Technical Service Information

FORD/MAZDA CD4E PERSISTENT GEAR RATIO ERROR OR TCC SLIP CODES

FORD/MAZDA CD4E

Figure 2

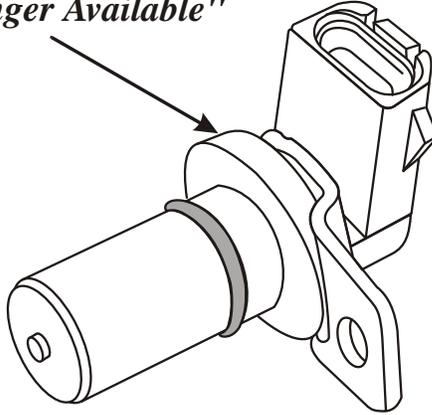
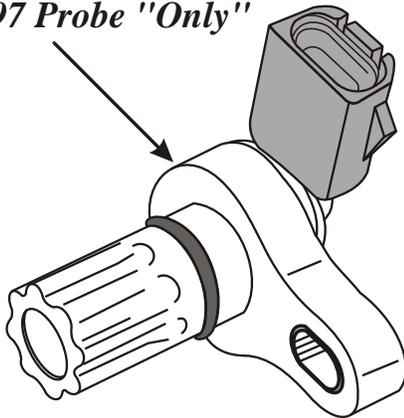
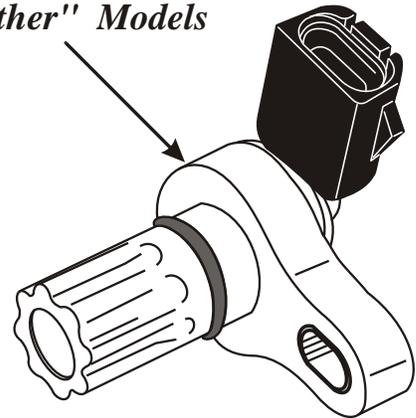
CAUSE: *The cause, believe it or not, is the replacement Turbine Speed Sensor.* The replacement TSS was redesigned and has an *enclosed* pickup as seen in Figure 2. The previous design TSS has an *exposed* pickup also seen in Figure 2. It seems, when the pickup was enclosed, the air gap between the TSS and the reverse clutch hub was increased. When the signal was checked and compared to the previous sensor signal, the new sensor signal exhibited a voltage difference but, when checked with an oscilloscope the previous sensor puts out a wider pattern than the current design sensor which means, the computer has more time to read the signal with the previous design sensor. In other words, with the current design turbine sensor, the computer does not have enough time to read the signal and may miss alternate signal pulses which causes the above complaint, on some models only.

*"All Black" Sensor
Part Number F7RZ-7M101-AA
"No longer Available"*

CORRECTION: Ford Motor Co. has now released a new design white TSS with a "green" connector that is to be used on 1994-1997 Probe vehicles, as shown in Figure 2. The new design white TSS with the "black" connector is to be used on "All Other" models using the CD4E transaxle, as shown in Figure 2. Install the proper TSS depending on the model that you are working on and service part numbers are shown below.

*White With "Green" Connector
Part Number F7RZ-7M101-KA
1994-1997 Probe "Only"*

*White With "Black" Connector
Part Number 1S7Z-7M101-KA
"All Other" Models*
